Subject: Amendment No. 1 to Clean Water Act Section 401 Water Quality Certification No. R9-2013-0076 for the Roripaugh Ranch Project

Amendment No. 1 to Clean Water Act Section 401
Water Quality Certification No. R9-2013-0076

PROJECT: Roripaugh Ranch Project
Certification Number R9-2013-0076

Attachment 1

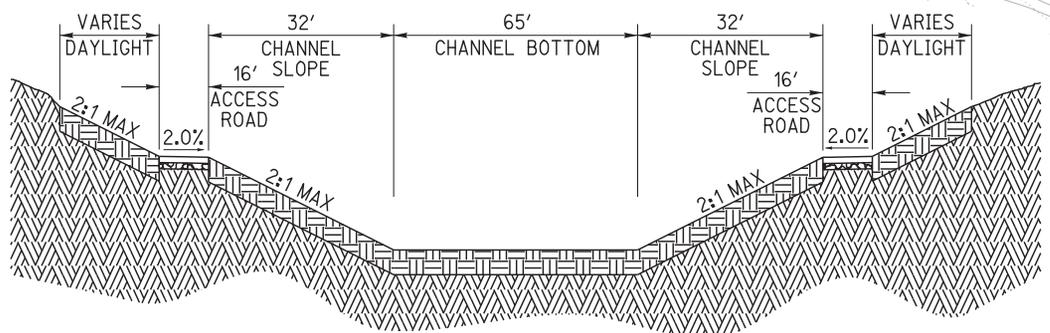
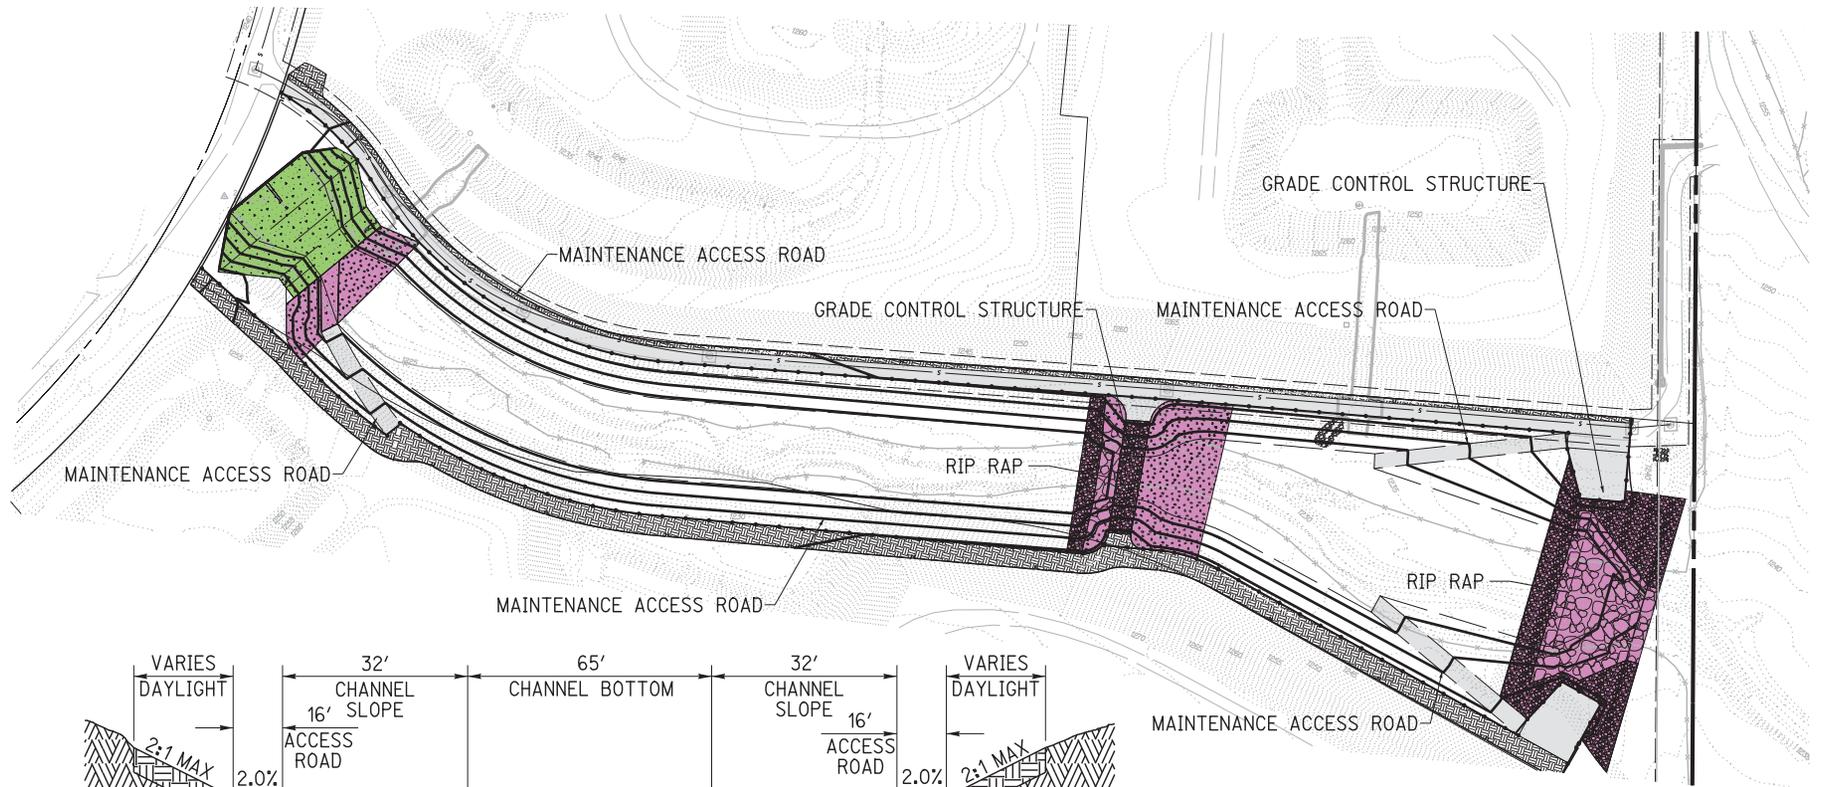
Long Valley Wash Upstream of Loop Road – The Project was originally permitted to construct an in-line sediment basin within Long Valley Wash upstream of Loop Road. The previous plans called for Armor Flex lining of the side slopes and the western portion of the channel bottom (Attachment 1). The channel bottom was to be fully maintained, including the periodic removal of sediment to limit downstream transport of sediment. The revised Project replaces the Armor Flex side slopes with earthen side slopes, places three grade control structures constructed of ungrouted rip-rap within the channel (Attachment 2), and eliminates the need for ongoing sediment removal. The revised design will allow for active sediment transport through Long Valley Wash and there will be the potential for some habitat to develop within the channel bottom and side slopes, as these areas will not need to be maintained for flood or sediment conveyance purposes.

Attachment 3

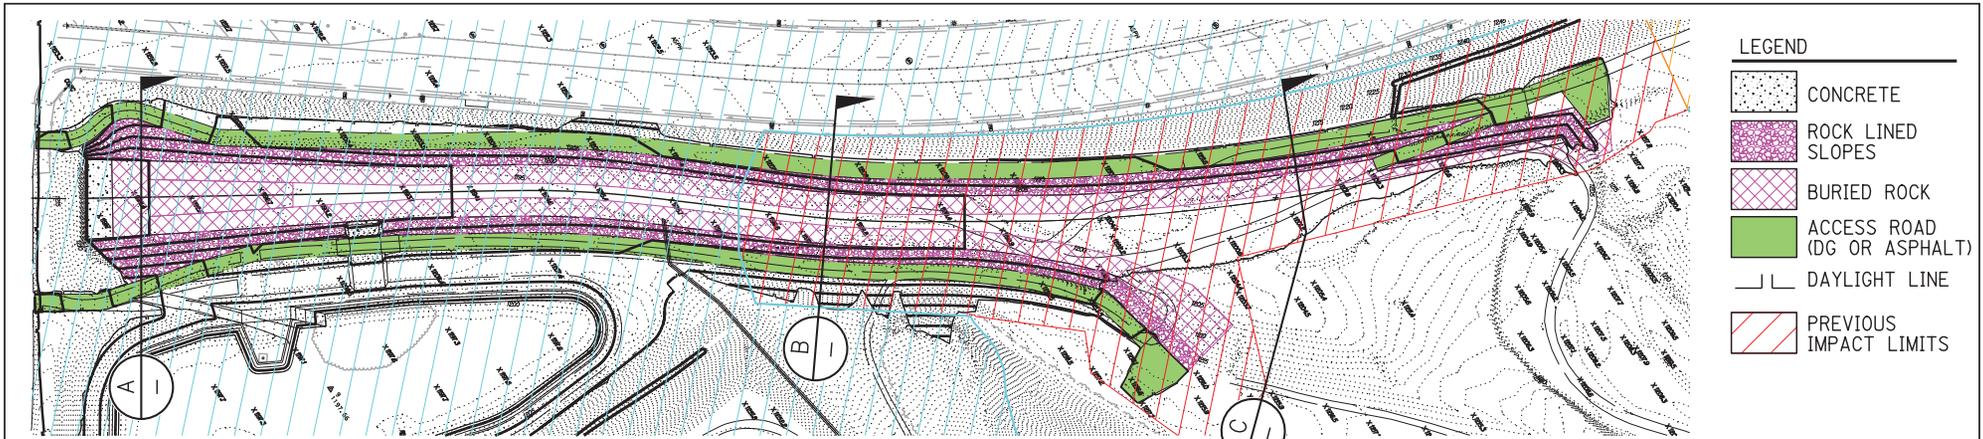
Santa Gertrudis Creek upstream of Butterfield Stage Road – The project was originally permitted to place Armor Flex along the length of the channel slopes and lower third of the channel bottom (Attachment 3). The channel bottom would be fully maintained. The revised Project replaces the Armor Flex side slopes with ungrouted rip-rap side slopes and buried rip-rap over a portion of the channel bottom (Attachment 4). The revised design may allow for a generally wider sandy bottom channel but is still

Santa Gertrudis Creek Channel

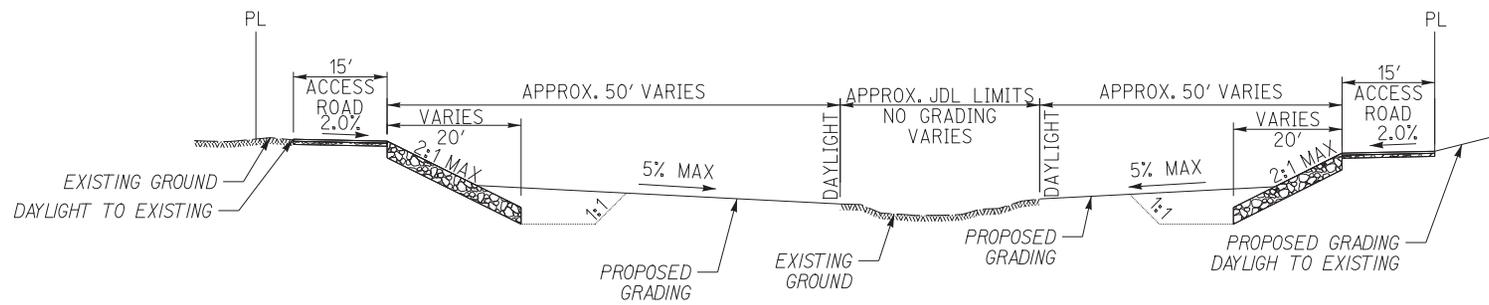
Santa Gertrudis Creek downstream of Butterfield Stage Road – Santa Gertrudis Creek was realigned to its current location as part of the previous grading conducted prior to 2004. The original approvals assumed that the channel would be lined with Armor Flex (Attachment 5). This portion of Santa Gertrudis Creek, including the previously approved lining of the channel with Armor Flex, was not included in the most recent permits. The applicant has worked to develop a design that avoids existing jurisdictional areas by widening the existing channel by up to 40 feet to the north side of the channel and using ungrouted rip-rap instead of Armor Flex. All work will occur in uplands at least five feet away from waters of the United States and/or State (Attachment 6).
